Product Change Notice (PCN)

Subject: Package assembly site addition for RZ/A1L (208pinLQFP)

PCN#:[EPPO-EX-25-0019-1]

Outline Drawing for current product:

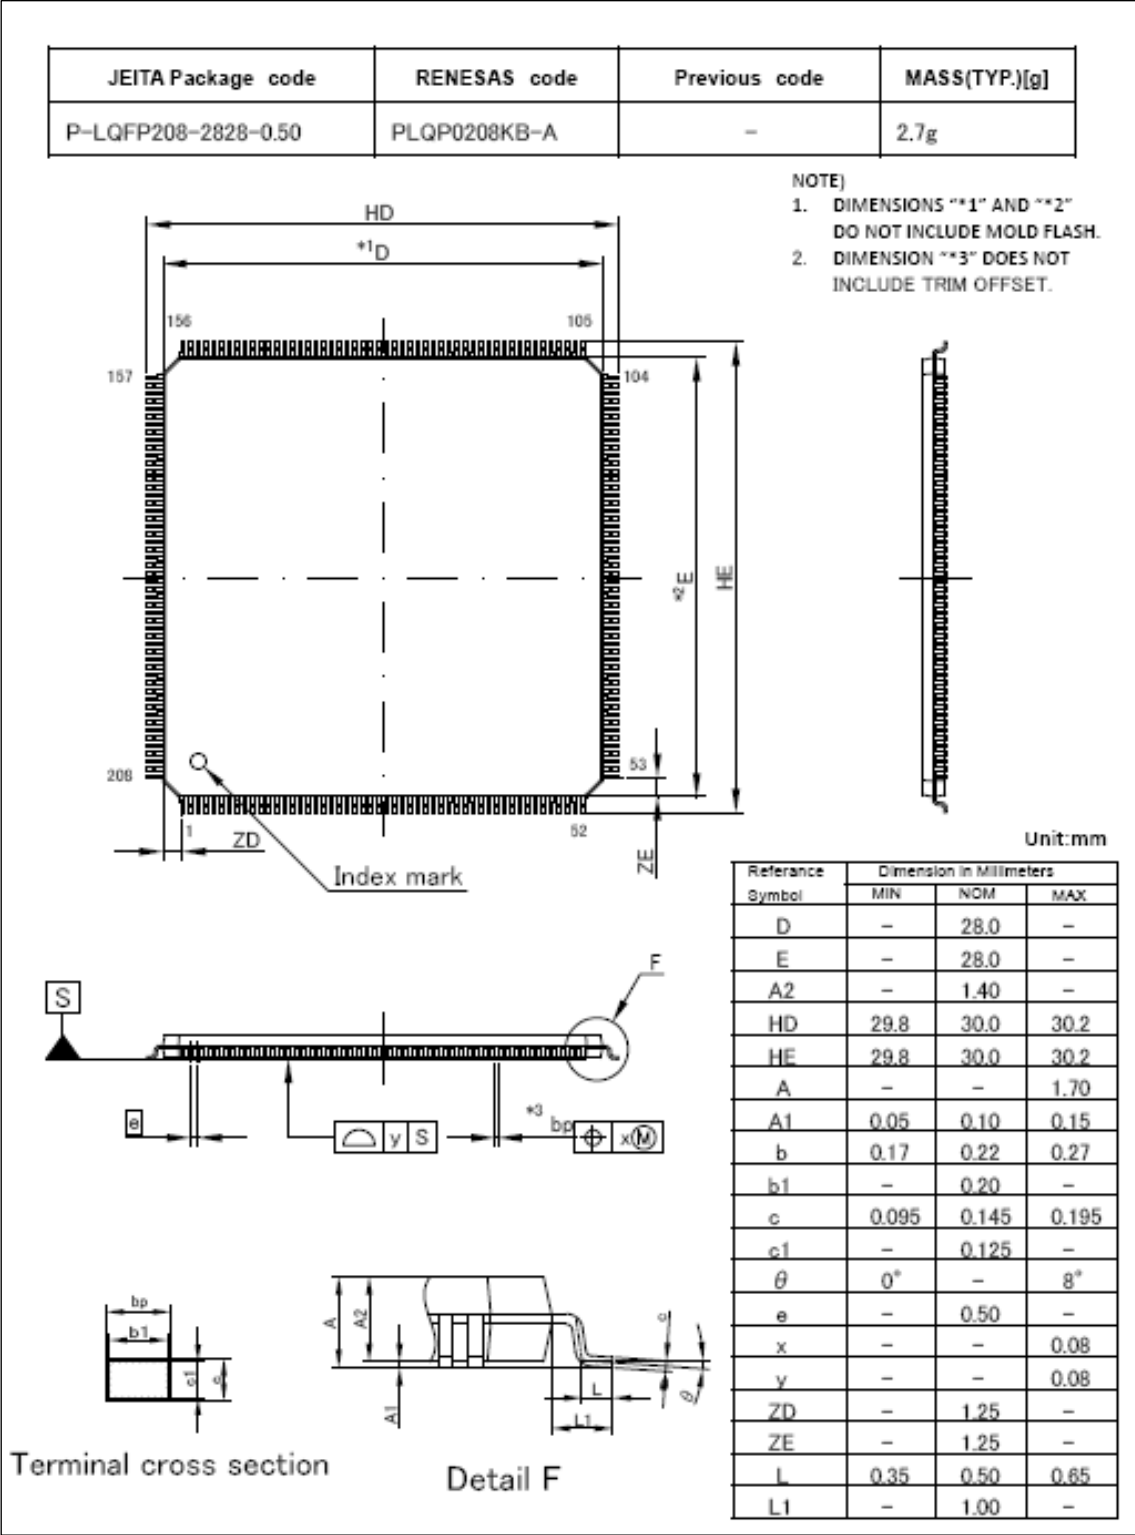
The Booking part numbers will be changed for identification because a part of package outline will also be changed from the current product.

Form : Drawings of the current product and additional product are shown in the appendix.
Package outline is considered equivalent.
